Enclosed please find a discussion of the final resolution of comments to the *Sampling and Analysis Plan for the D&D Groundwater Monitoring of Buildings 444, 771, and 886*. This discussion summarizes the results of the meeting held among the Rocky Flats Environmental Technology Site staff, the Environmental Protection Agency, Region VIII, and your organization on July 21, 1999

Below are the final comment resolutions remaining from the July 21st meeting with EPA and CDPHE that pertain to the Building 444, 771, and 886 D&D Groundwater Monitoring Sampling and Analysis Plan

**Figure 1-2**  
**Building 771 Site Location**  
**Existing and Proposed Monitoring Wells**

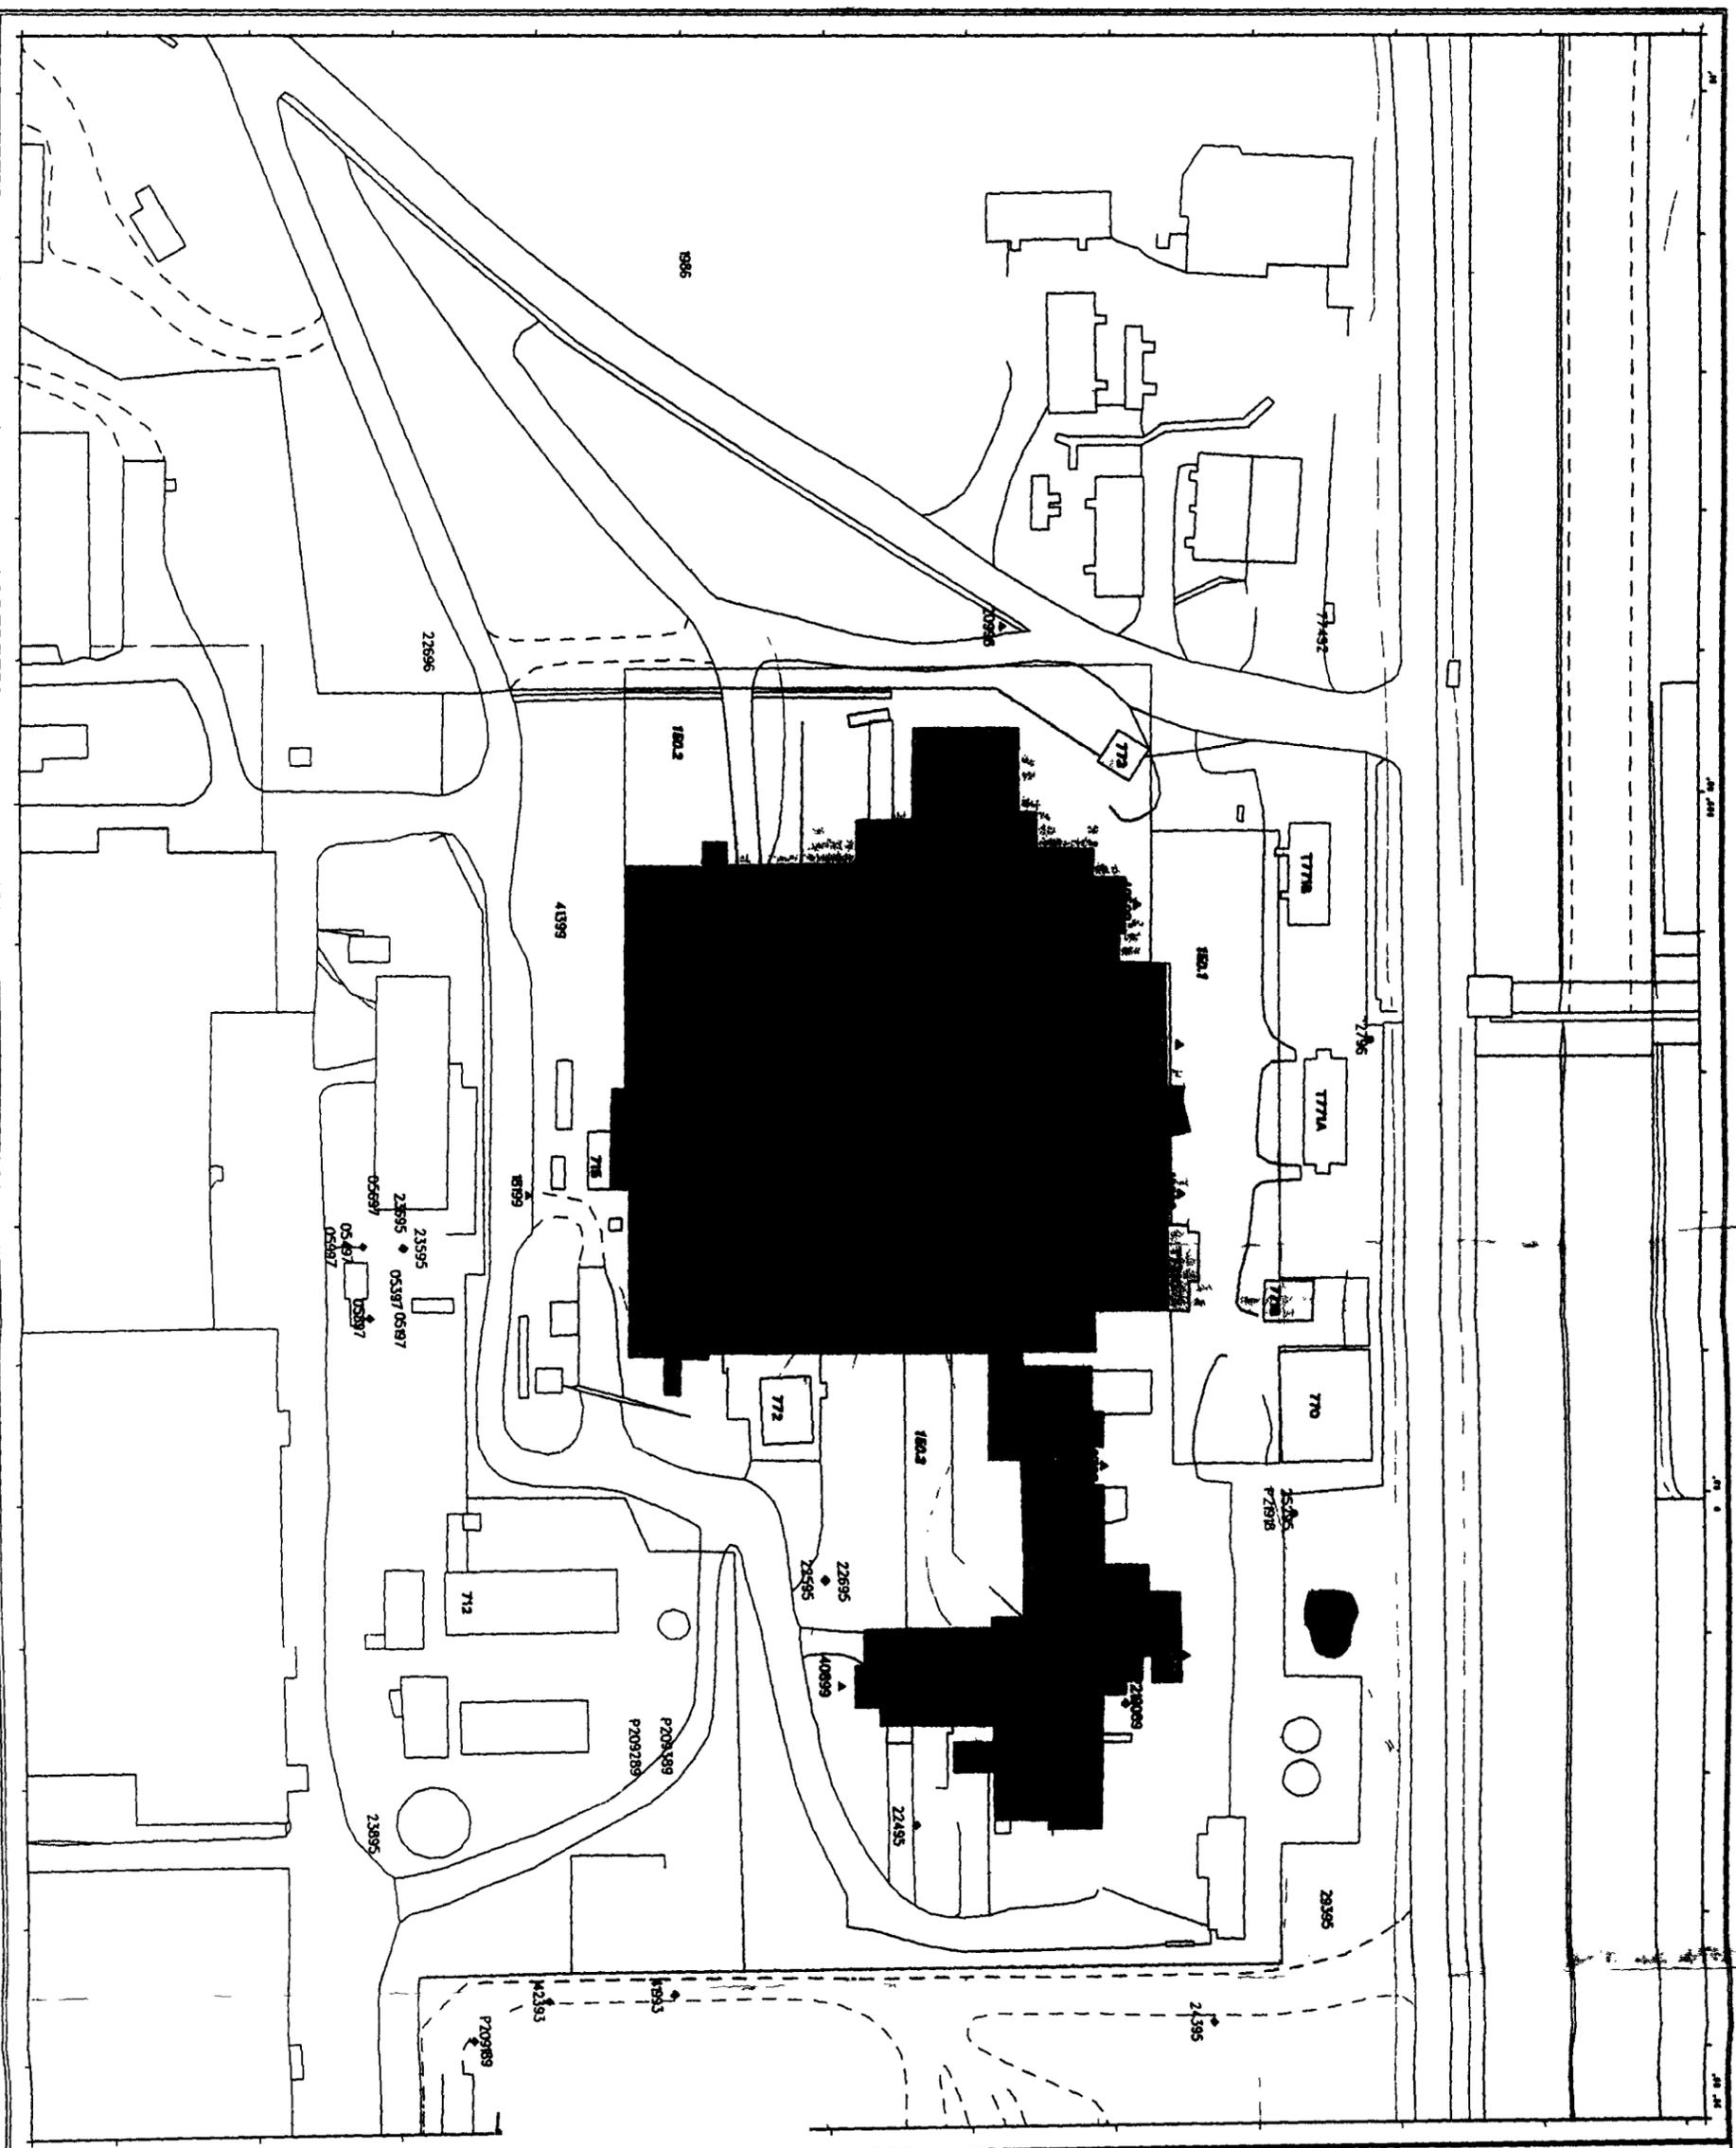
**CDPHE Comment.** Section 4.1.2, page 25 - The proposed sampling scheme at Building 771/771C/774 should be modified. Another well should be added along the north side of Building 771 between wells 40599 and 40699, and a well needs to be added north of the northern extent of Building 774

**EPA Comment:** Regarding building 771, two or three wells are needed on the west and south sides of the building in order to provide a better understanding of the existing contaminant plume and flow paths

*Seven new monitoring wells and two existing wells will comprise the monitoring network at Building 771 (see Figure 1-2). Additional wells have been added to the west, south, and north sides of the building complex in response to EPA and CDPHE comments recommending improved coverage in these areas. Well P219089 has been replaced by a new monitoring well located at the northern end of Building 774 to better monitor post D&D groundwater conditions associated with the foundation drain system of this building. These changes are reflected in a page revision to the controlled SAP (see attached page 25)*
